## **Planning Commission Staff Report**

**Project Type:** Site Development Section Plan

**Description:** **Chesterfield Commons Seven, Lot 1 (Wendy's)**: A Site Development Section Plan, Landscape Plan, Architectural Elevations, and Architect's Statement of Design for a 1.06 acre tract of land zoned "PC" Planned Commercial District located on the north side of Chesterfield Airport Road, one-half mile west of the corner of Chesterfield Airport Road and Boone's Crossing.

| ELECTRICAL PHOTOMETRIC PLAN |                | SCALE: NONE |            |

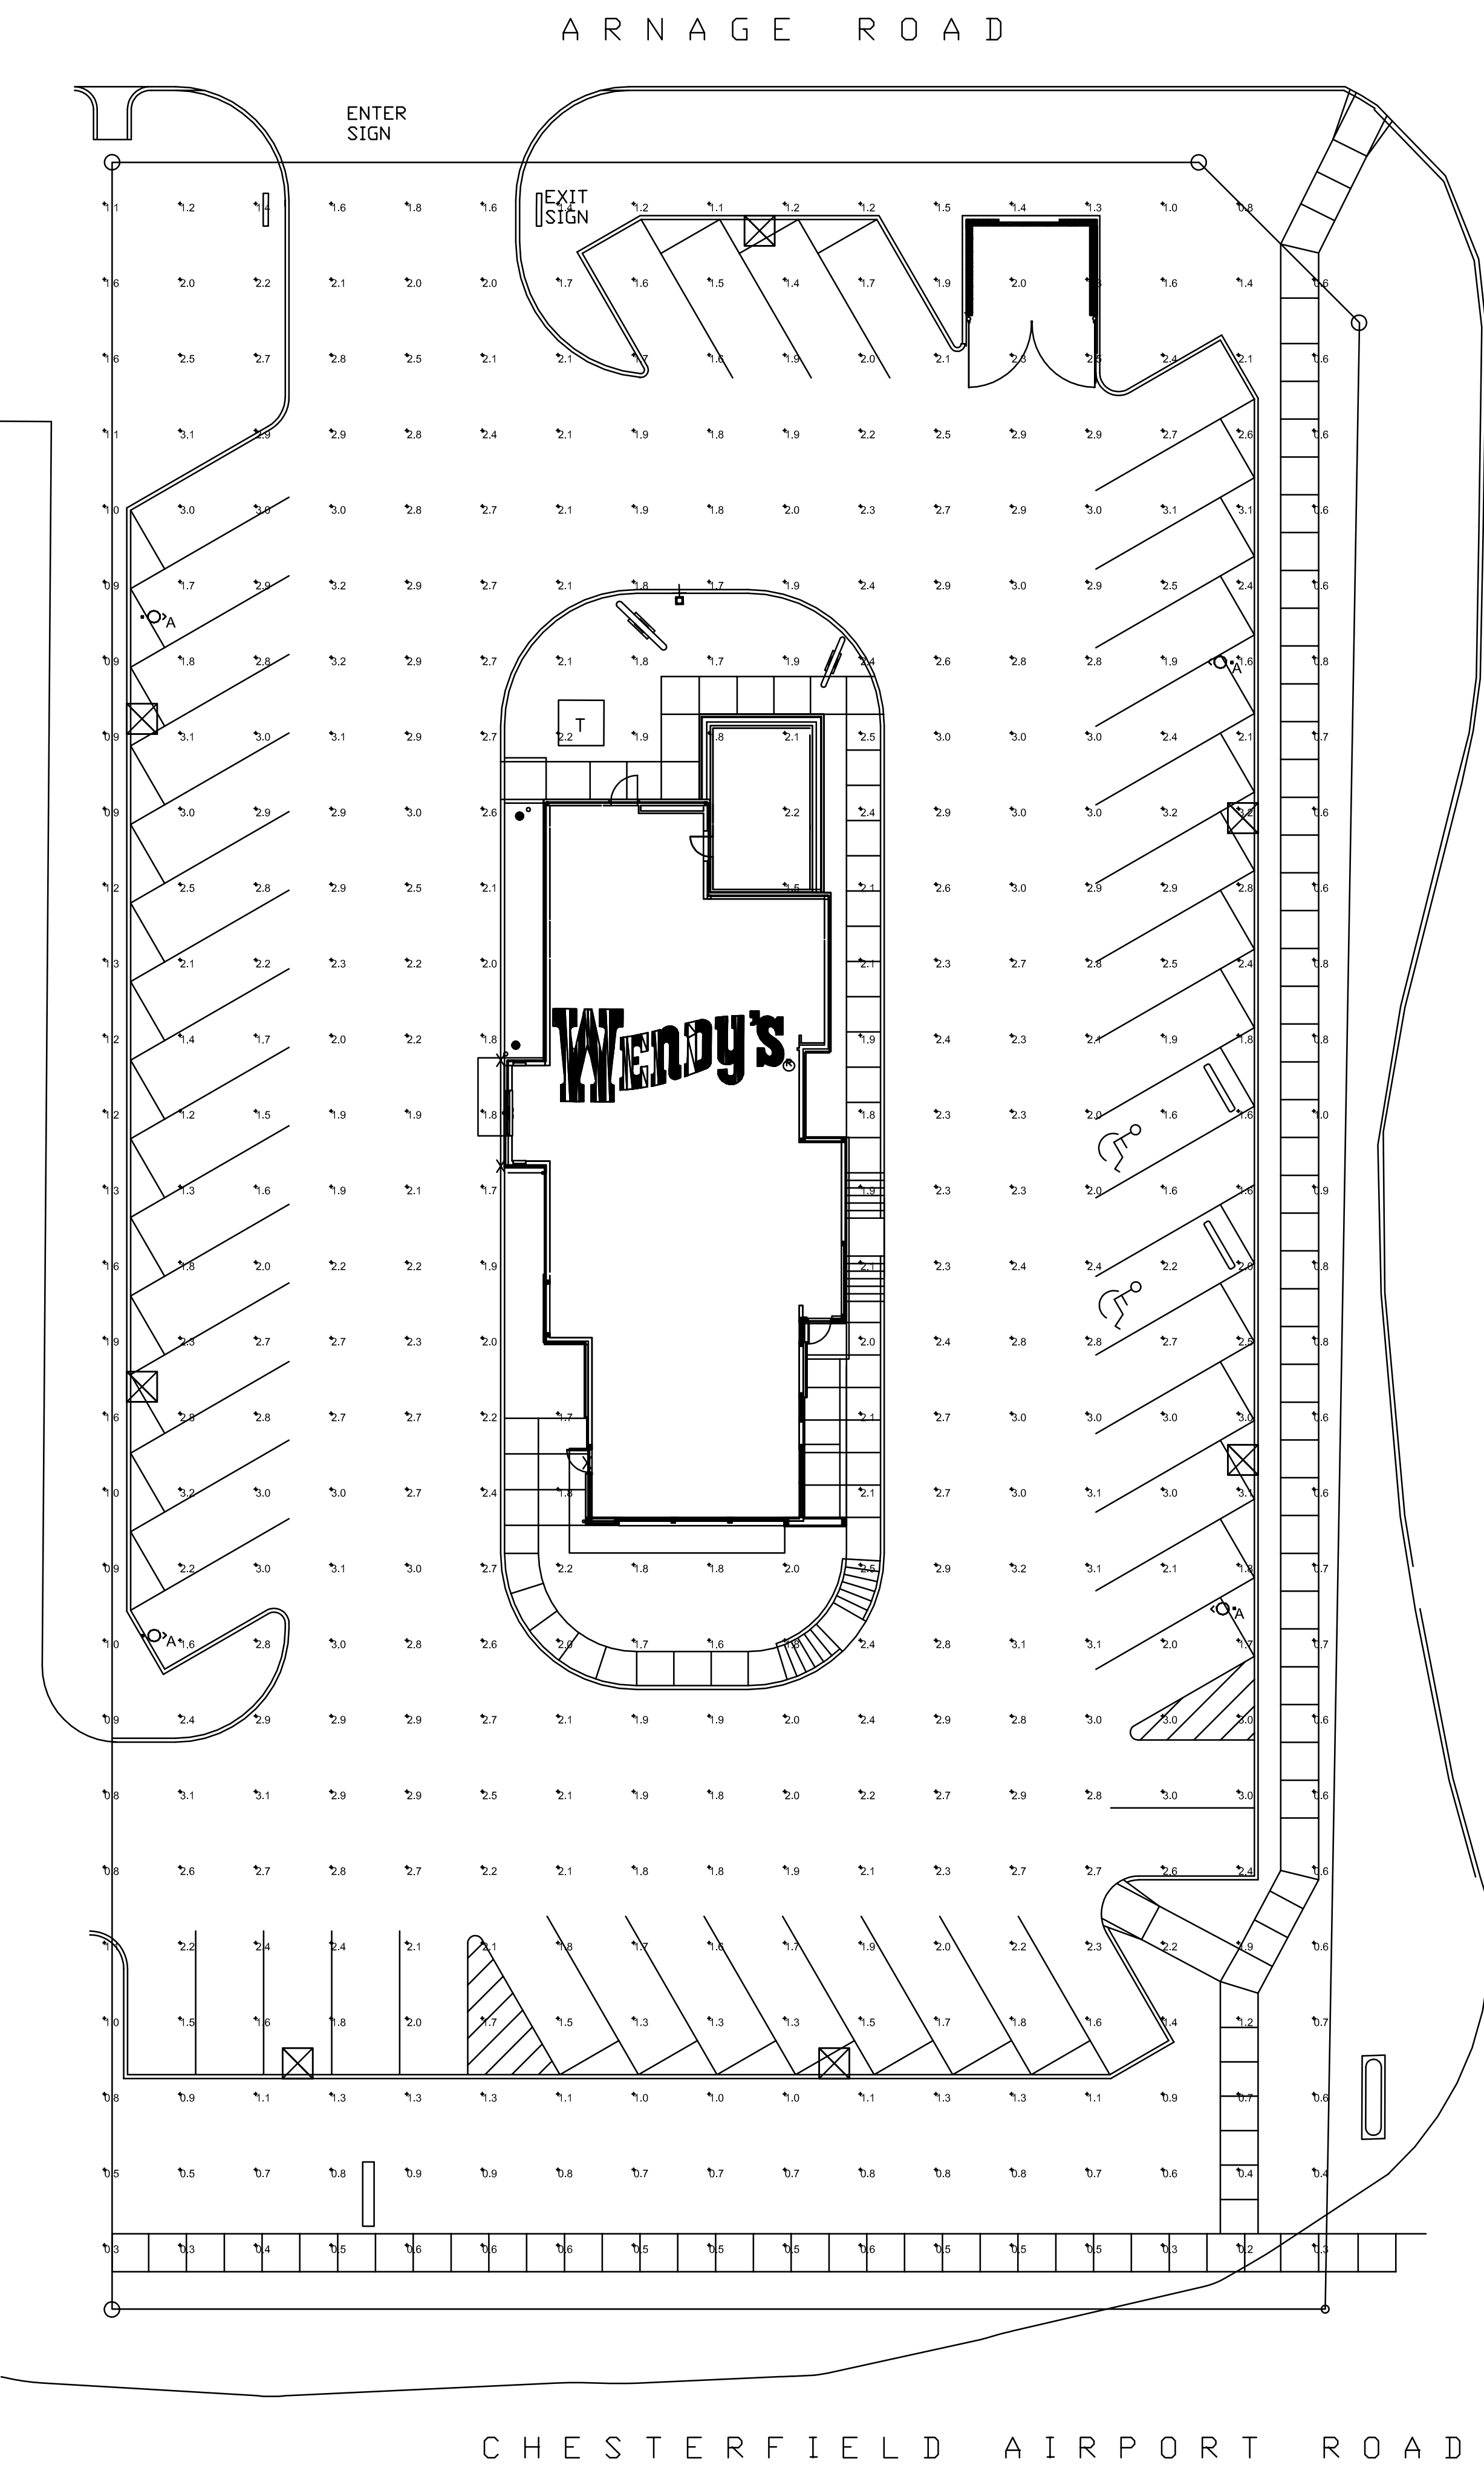
A Lighting Plan has been submitted with pole mounted parking lot fixtures in the parking lot. The fixture design adheres to the City of Chesterfield Lighting Ordinance however the proposed mounting height of the parking lot fixtures is thirty-three (33) feet. The Lighting Ordinance states that the height of all light standards shall be reviewed by the Planning Commission. The applicant previously had submitted a request to allow a mounting height of thirty-three (33) feet for the development and has been approved.

1. Mounting height 33' (30'pole, 3'base)
